V2500-D5 SERIES PROPULSION SYSTEM SERVICE BULLETIN

This document transmits the Initial Issue of Service Bulletin EV2500-70-0829

INFORMATION – ENGINE – PROVIDE A NEW NO. 4 BEARING COMPARTMENT GASKET AND LOCK

FAMILY TREE GASKET AND LOCK. REF. CATALOG SEQUENCE NUMBER 72-42-20. FIGURE 1 ITEMS 220 AND 300.

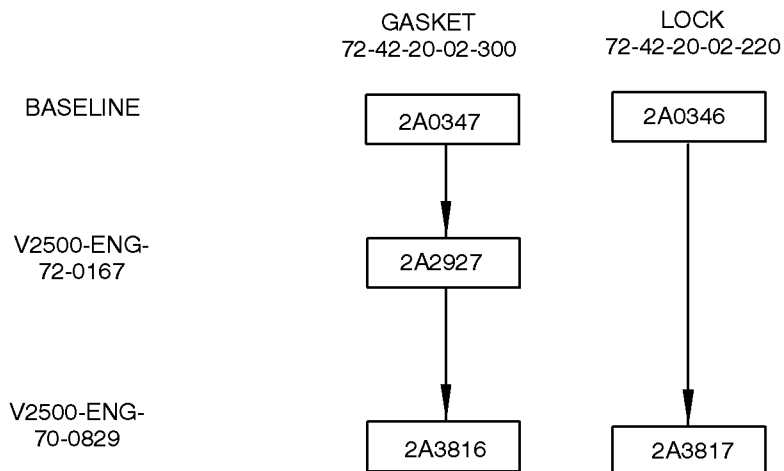
Parts Progression To Show the Changed Part in Relation to Other Parts

PART NUMBER CHANGE

New PN	Qty	Estimate of Unit Price (\$)	Keyword	Old PN (ATA/Figure/Item)	Inst – Disp
2A3816	1	20.60	.Gasket	2A2927 (72-42-20-02-300)	(2)(A) (L)
2A3817	1	271.00	.Lock	2A0346 (72-42-20-02-220)	(2)(A) (L)(I)
